May 9, 2023

ADDENDUM NO. 1

RE: Item #1, May 17, 2023 Letting - NH 0018(157)438, PCN 6923, Lincoln County - Grading, PCC Surfacing, Asphalt Concrete Surfacing & Replace Str RCBC (2 - 9'x5' Precast or CIP; 2 - 12'x5' CIP RCBC)

| STATE OF SOUTH DAKOTA | PROJECT NH 0018(157)438 | SHEET NO. B76 | TOTAL SHEETS B139 |

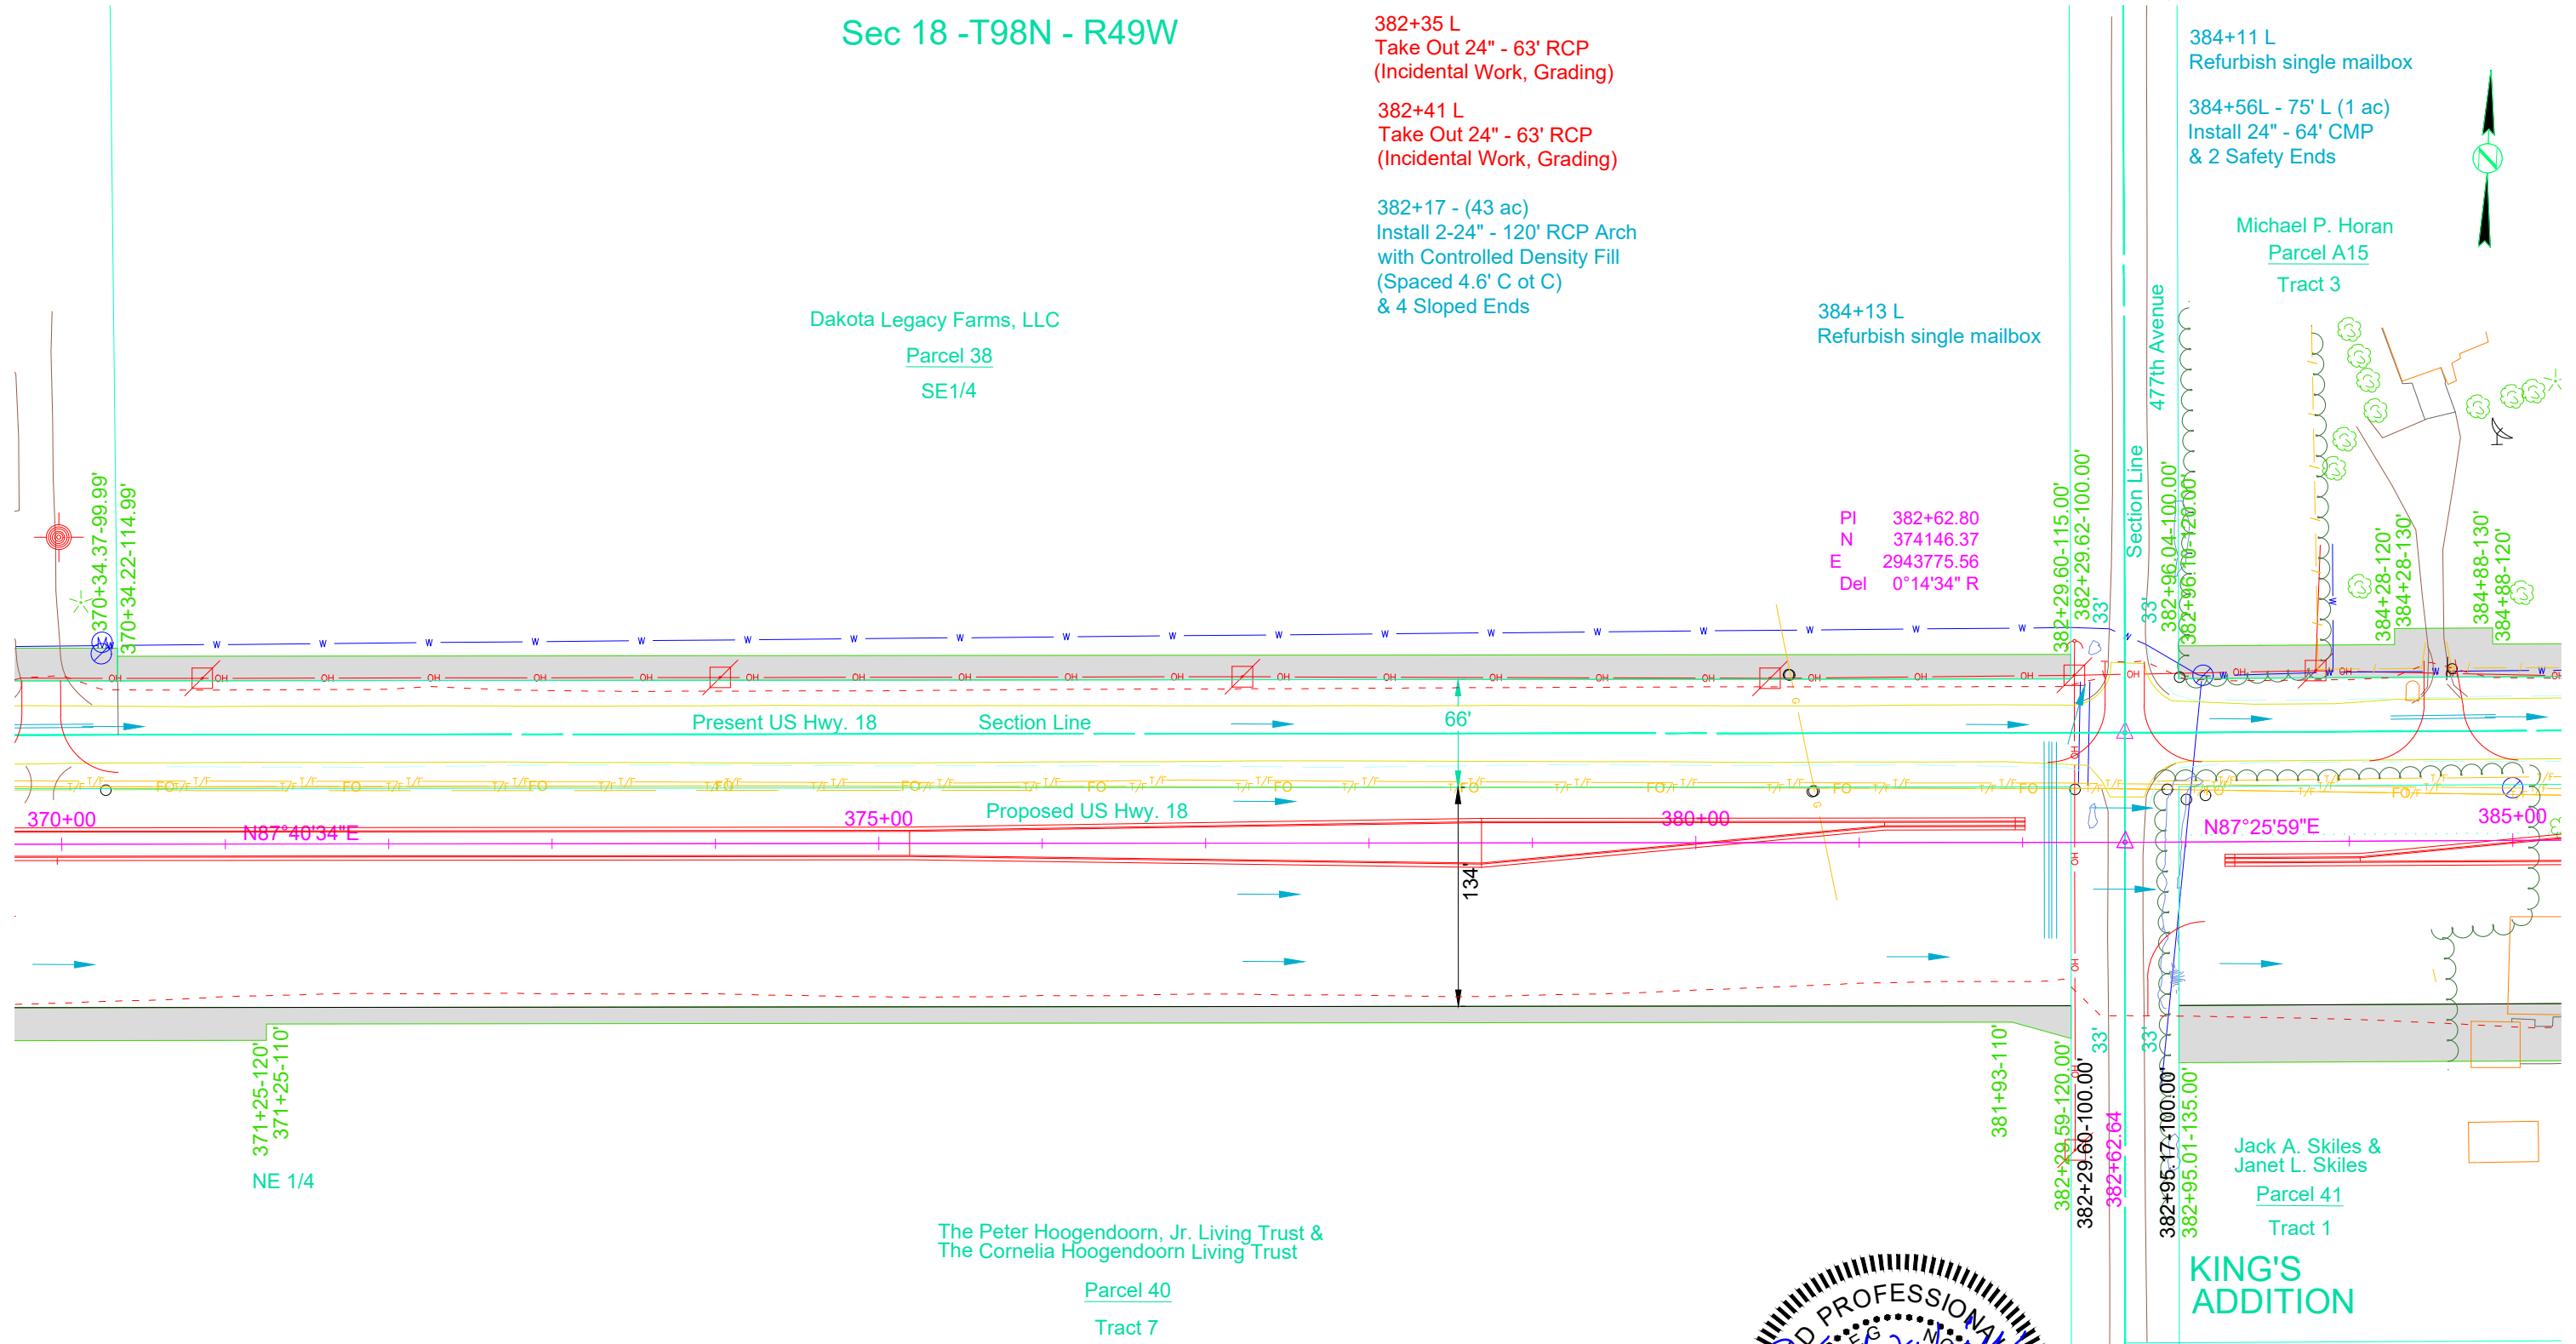
- Sheets B74 & B75:** Sta 357+50 Junction Box was revised.
- Sheets B76 & B78:** Salvage Existing Vinyl Fence and Gate notes were removed.
- Sheets B112 – B117:** Special Junction Box details were revised.

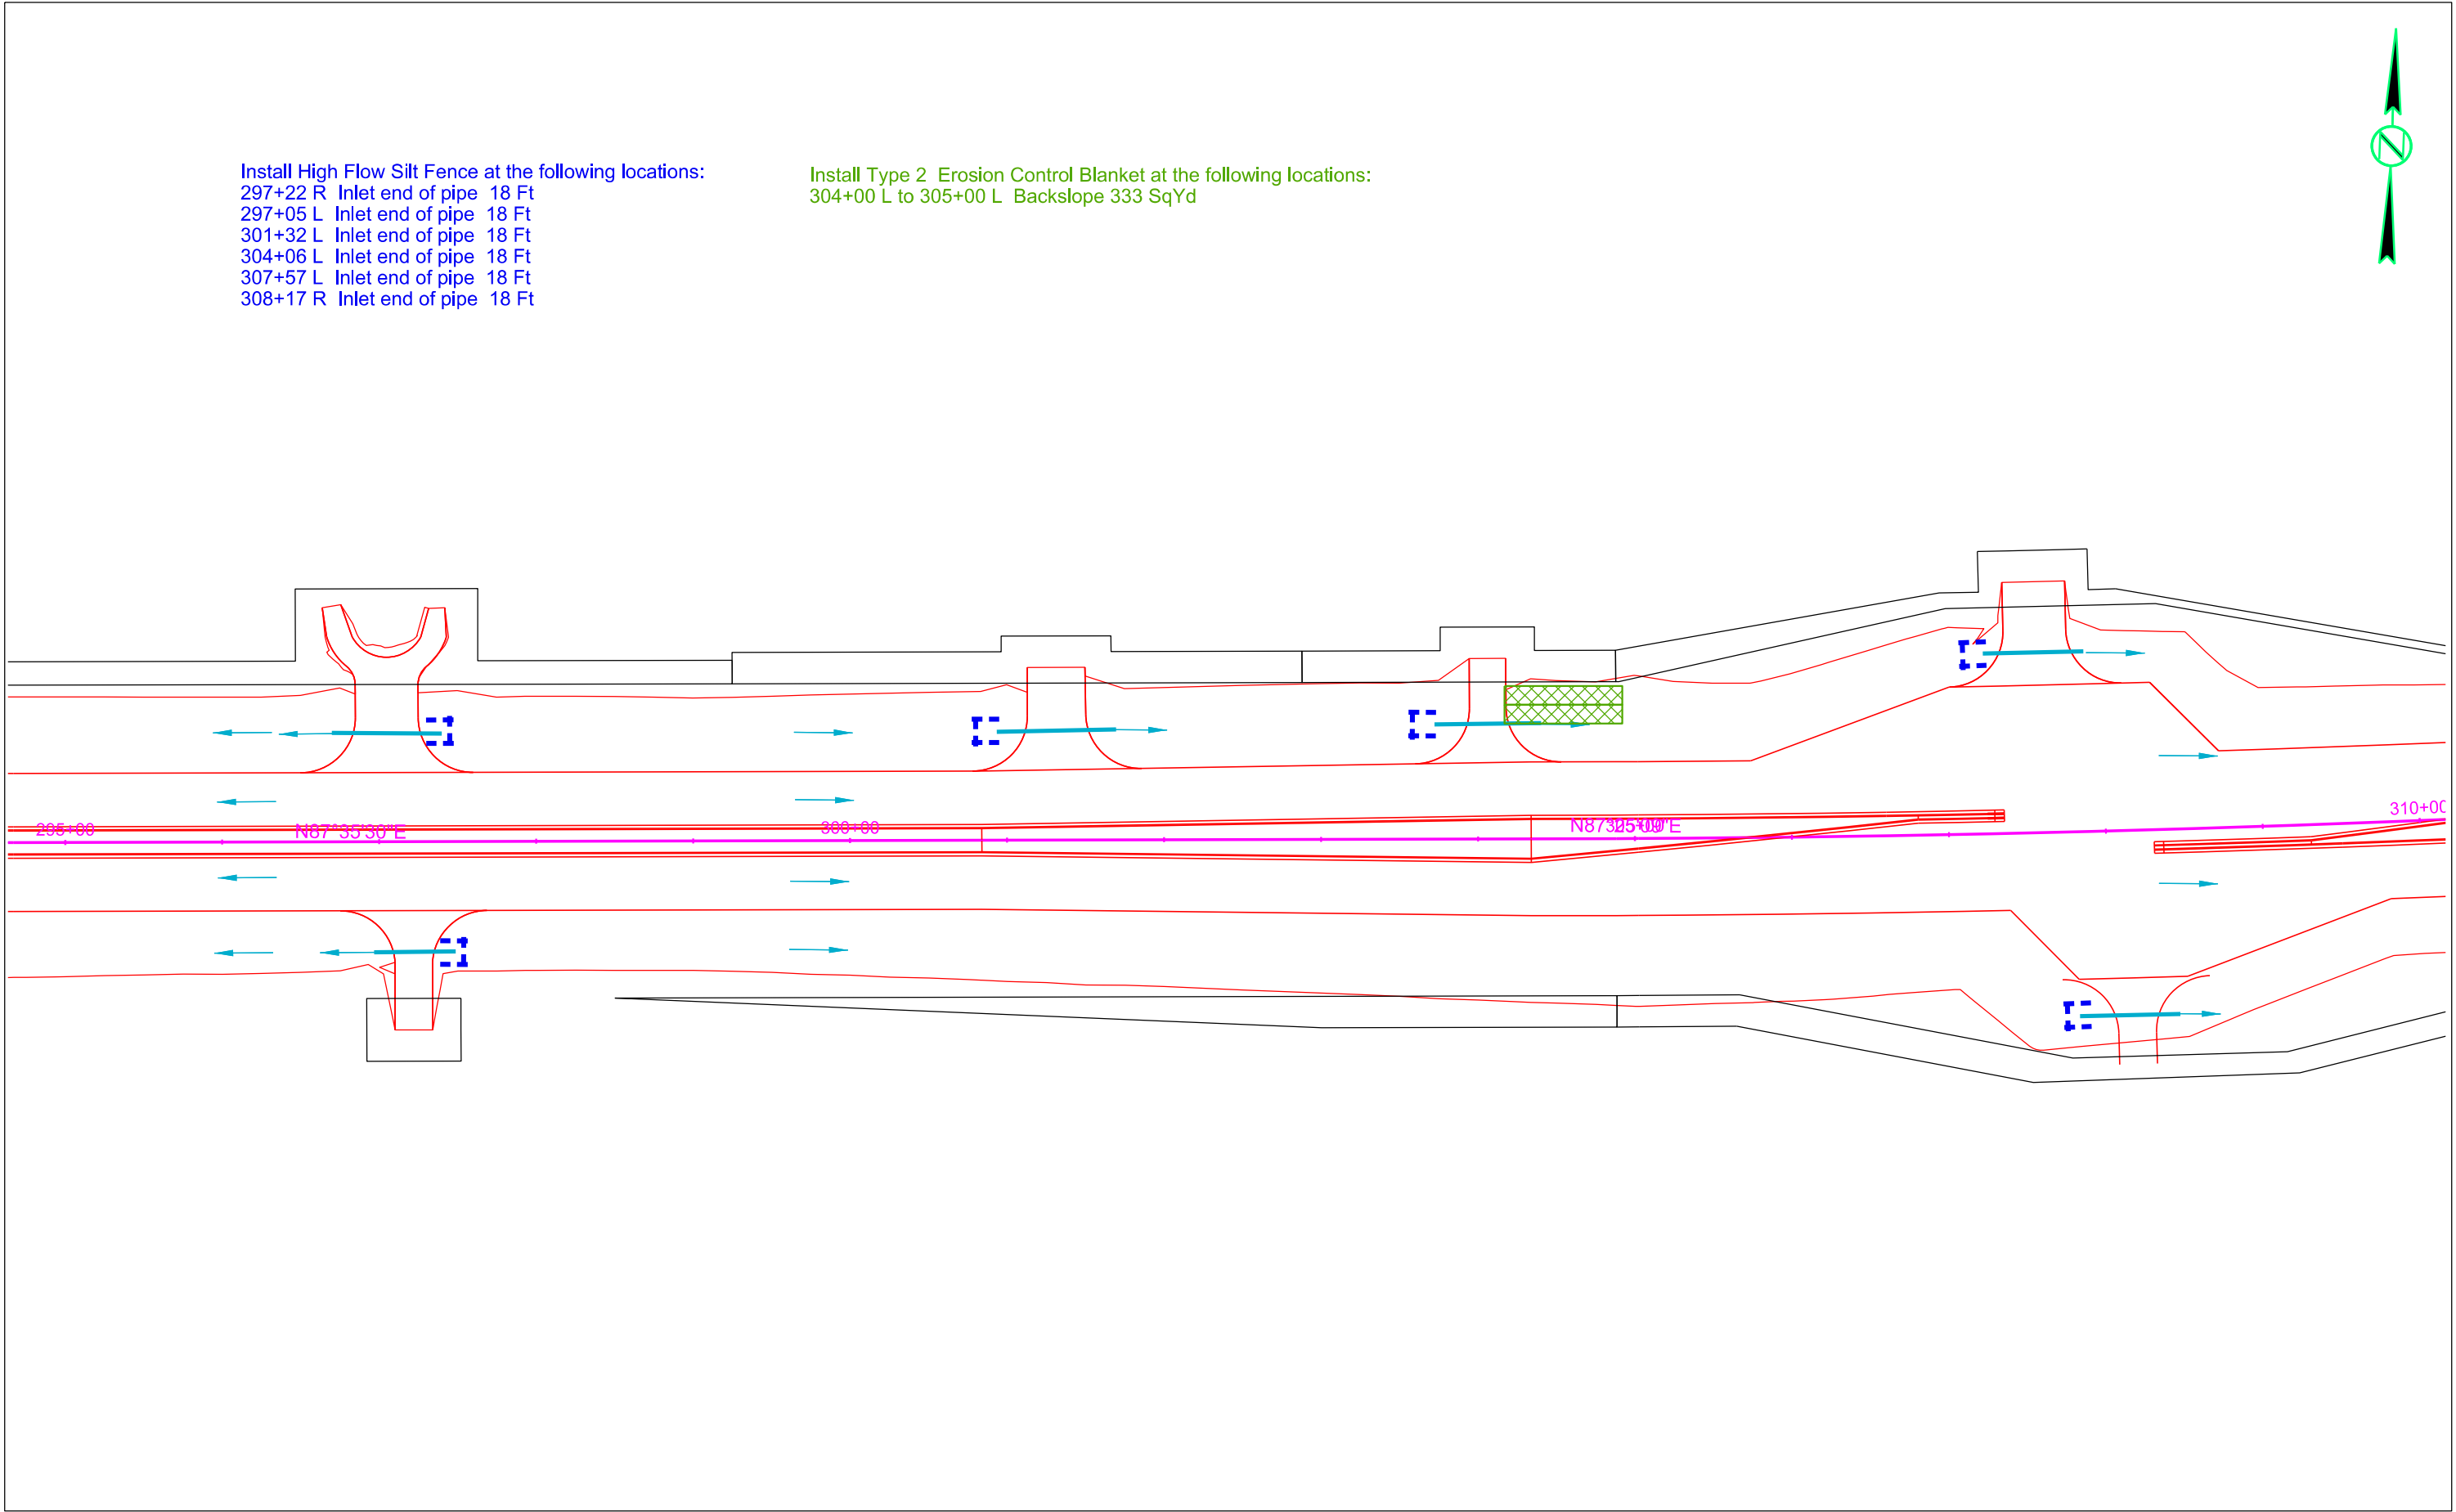
- Sheet D6:** TABLE OF SEDIMENT CONTROL AT INLETS WITH FRAMES AND GRATES was revised.
- Sheet D29:** High Flow Silt Fence at 308+17R was added.
- Sheets D30:** Sediment control at Sta 324+21'R was removed.

| | NH 0018(157)438 | Z3 | Z19 |

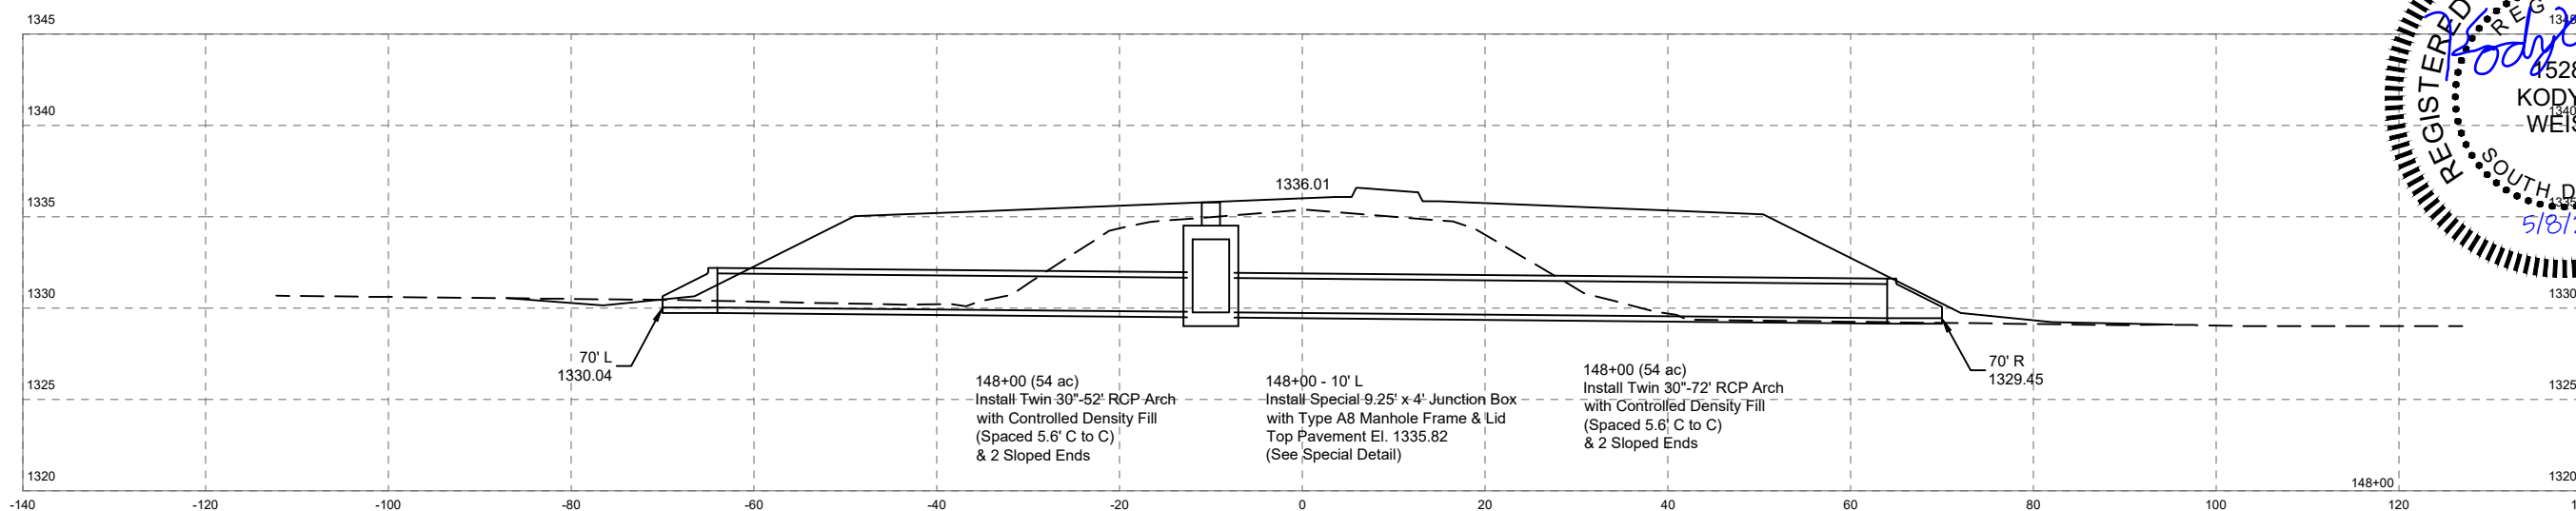
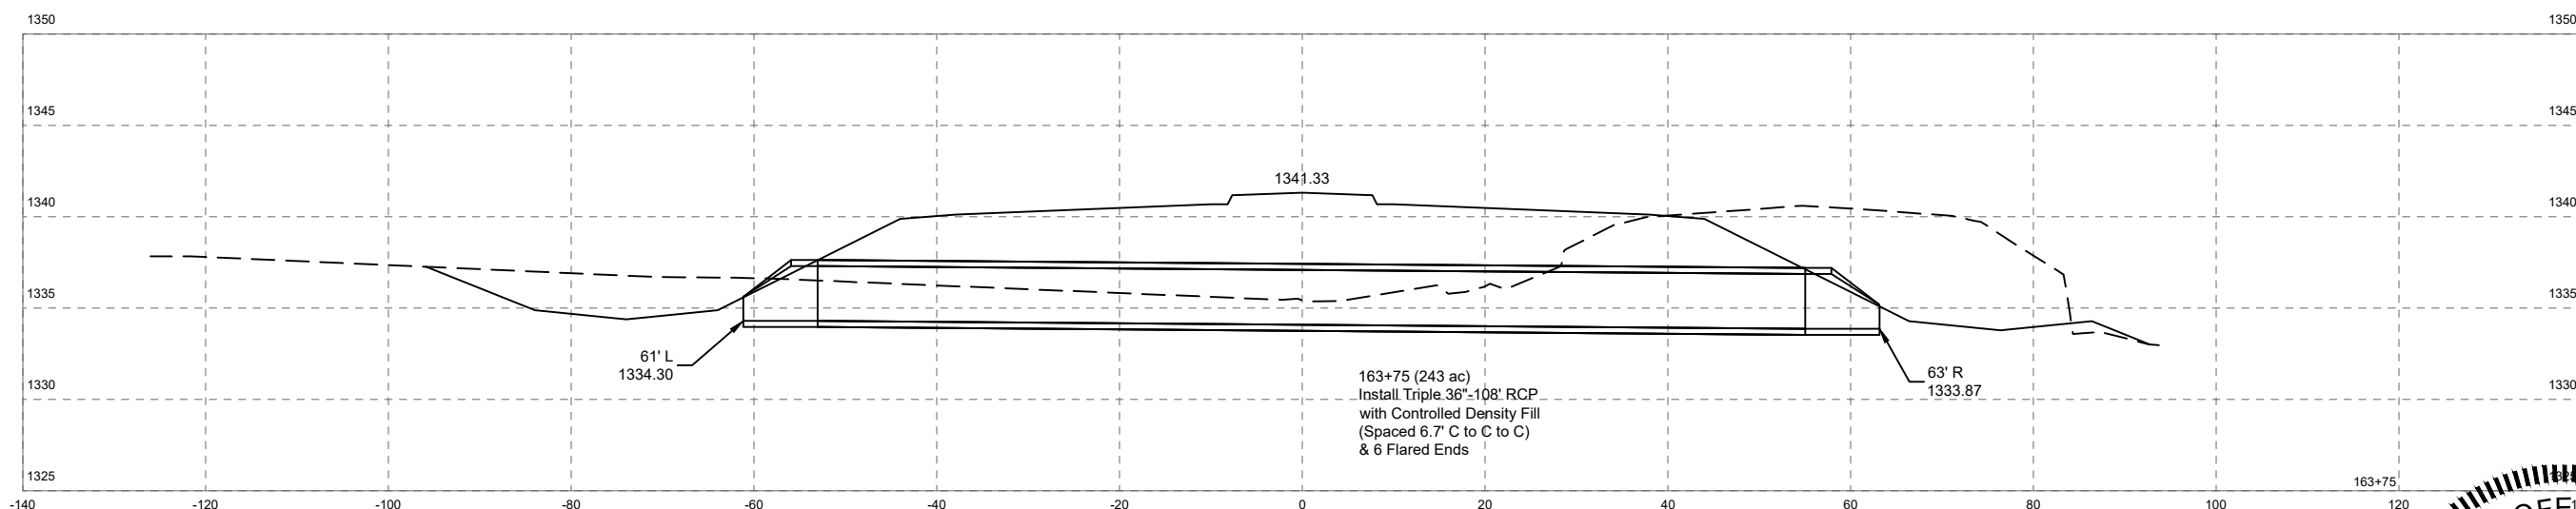
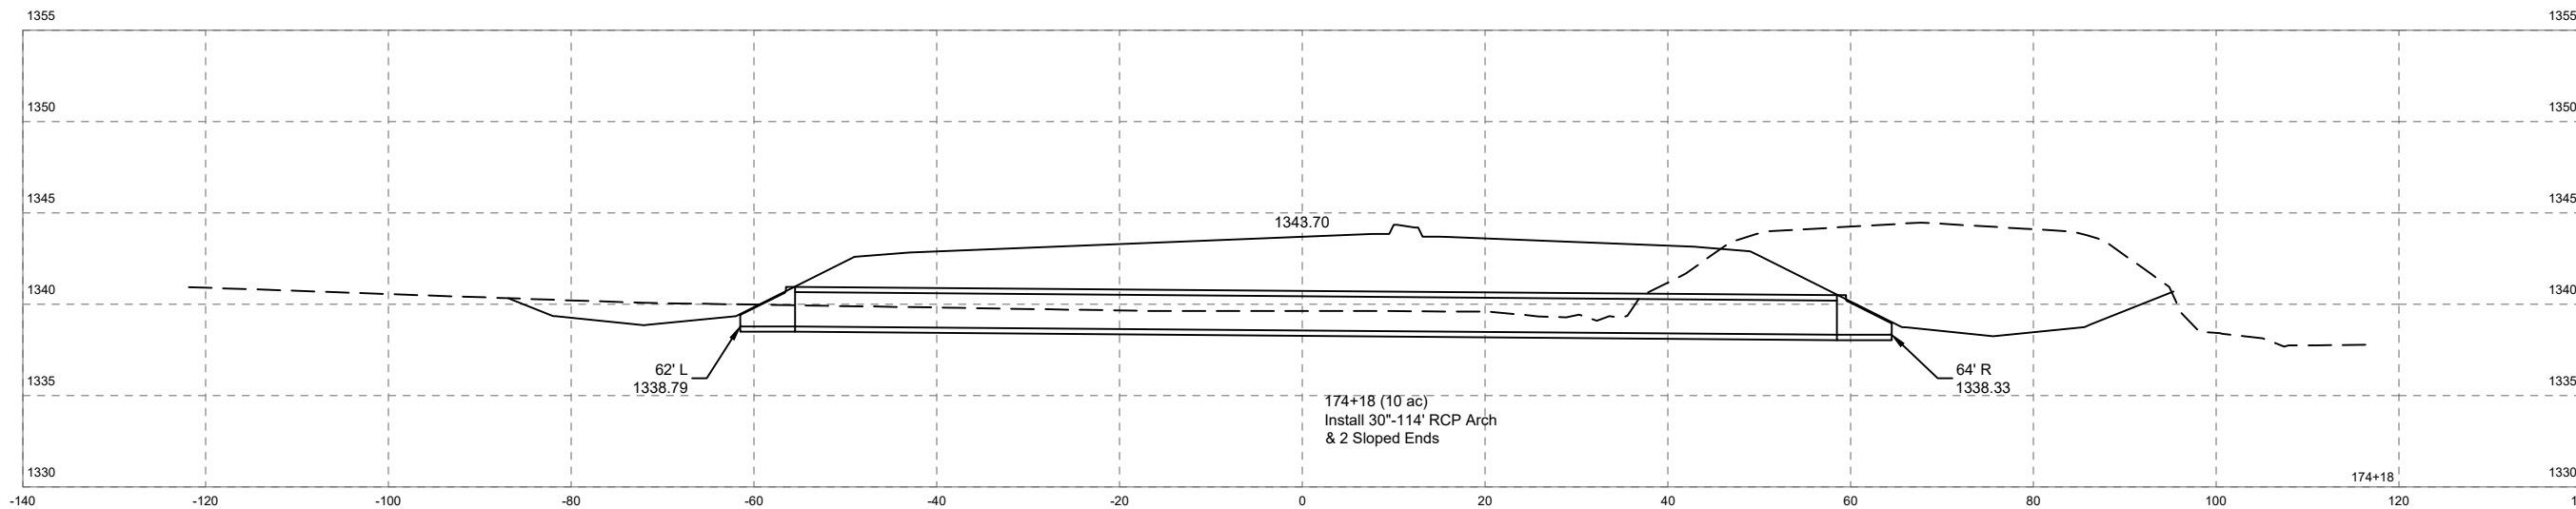
- Sheets X55 & X56:** Curb & Gutter on right was removed from Sta 325+00 to Sta 330+00.
- Sheets Z3, Z4, Z6 & Z7:** Junction Box notes were revised.
- Sheet Z14:** Drop Inlet at Sta 324+20.62 was removed. Pipe at Sta 308+17R was added.
